ADDENDUM NO. 1

NEW BUILDING FOR CELINA ELECTRICAL DEPARTMENT

CITY OF CELINA, OHIO

Project No. 220803.02

DATE: 7-27-21
H-1

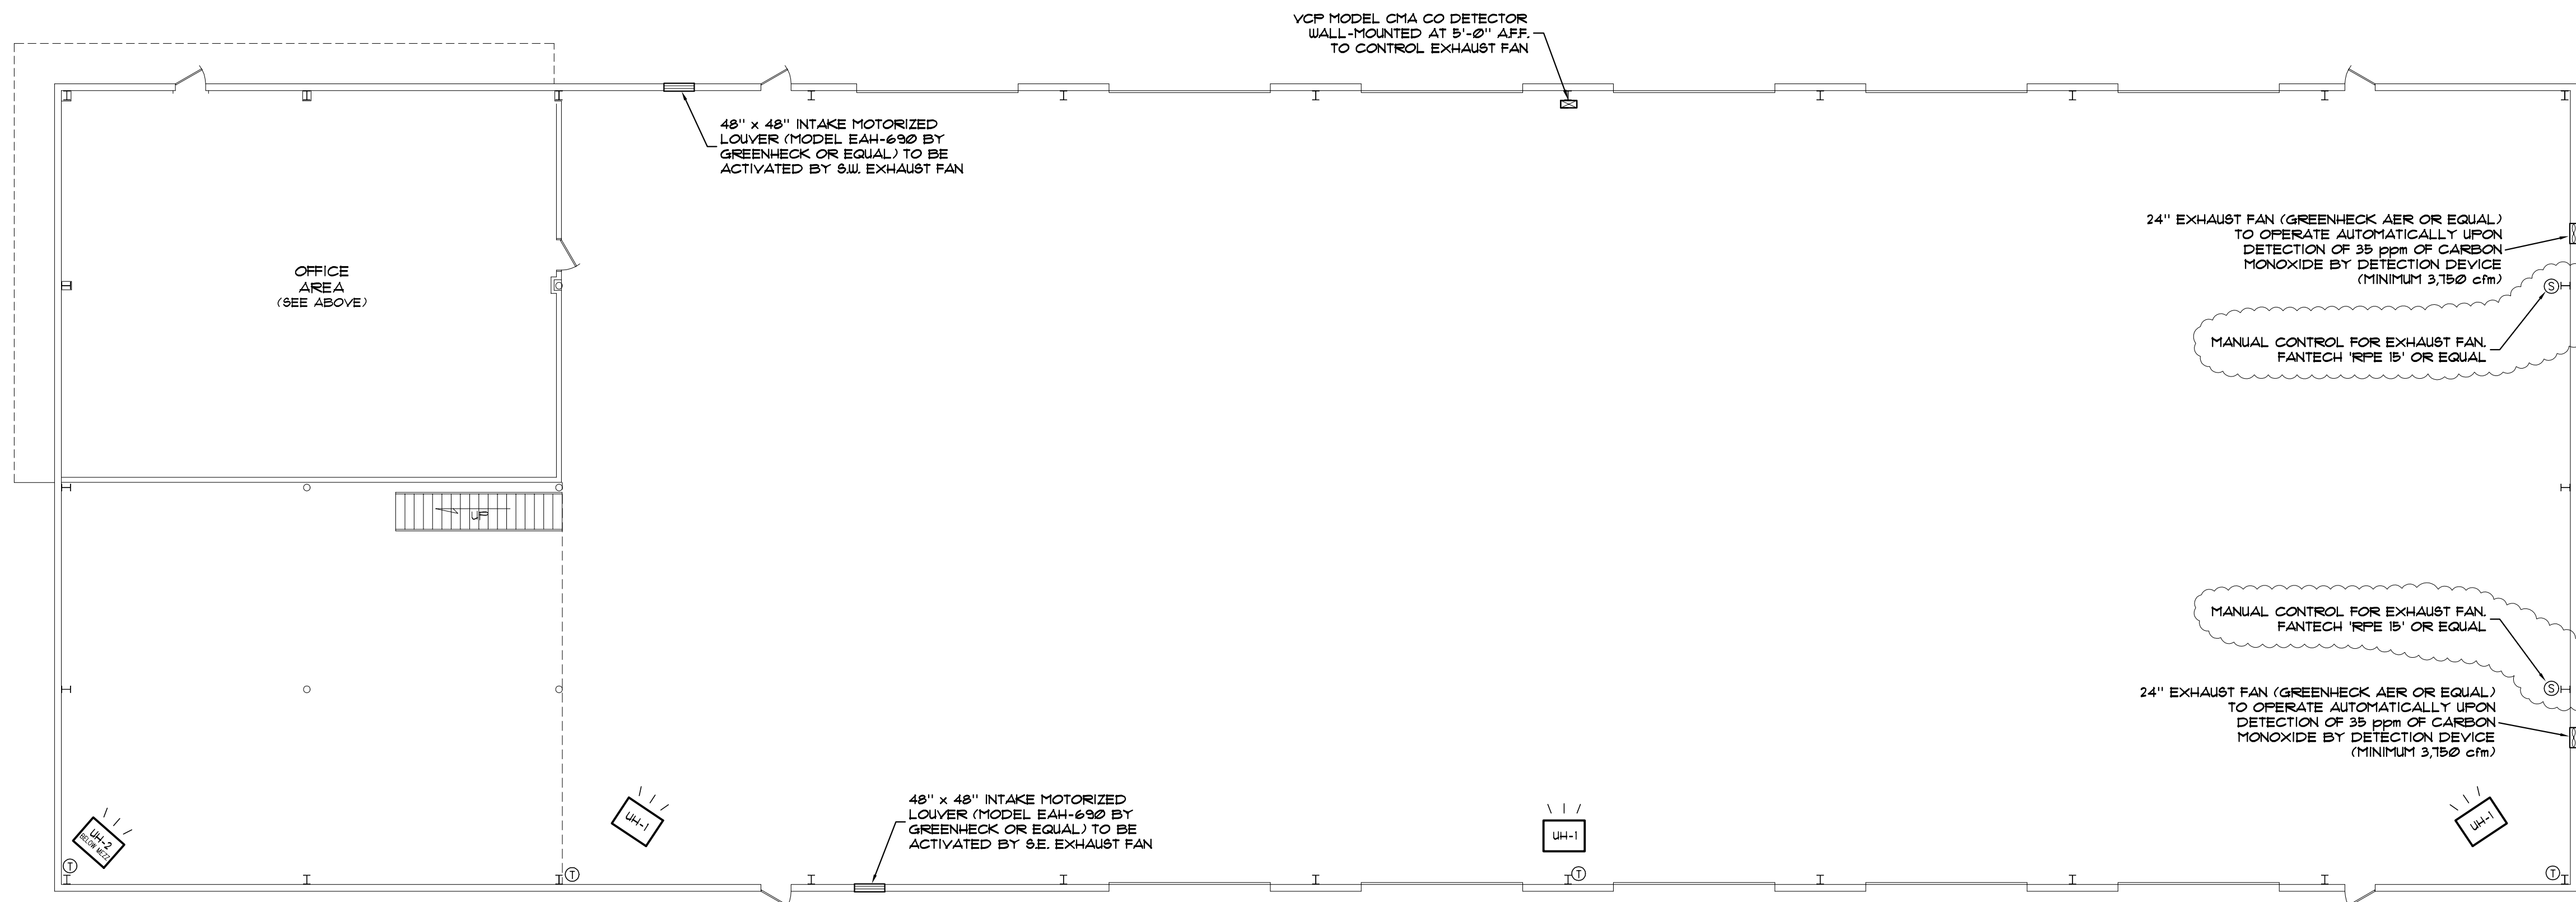
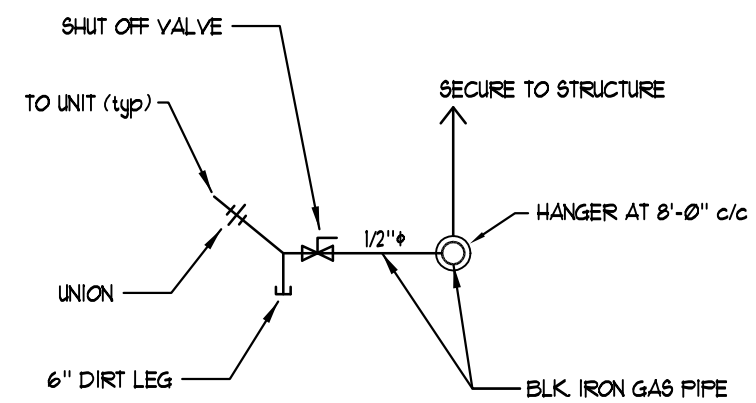
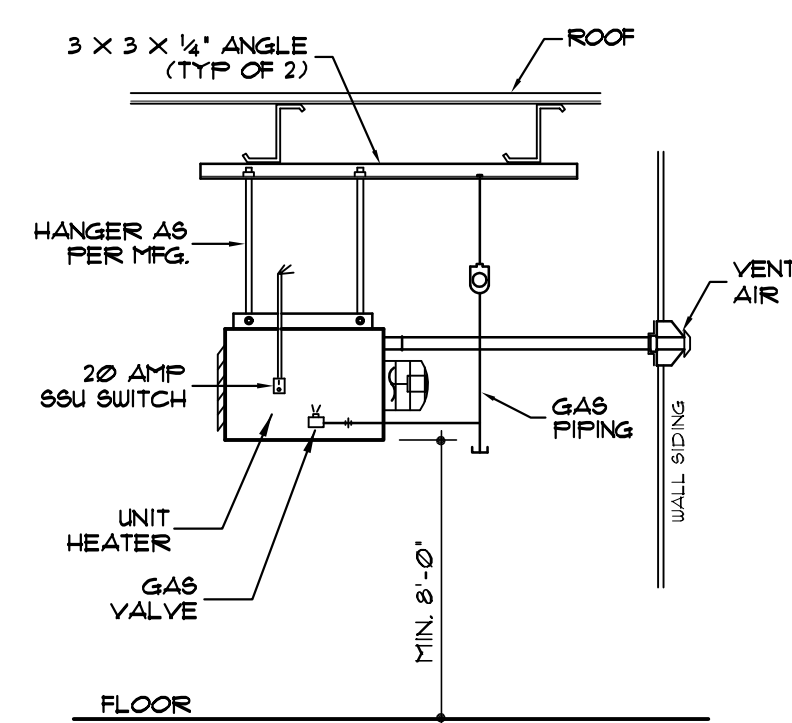
ITEM NO. 6 – Construction Drawings – Sheet H-1

- a) The attached revised Sheet H-1 drawing will replace the original drawing included in the bid documents. The revision to the drawing includes the addition of manual exhaust fan controls.
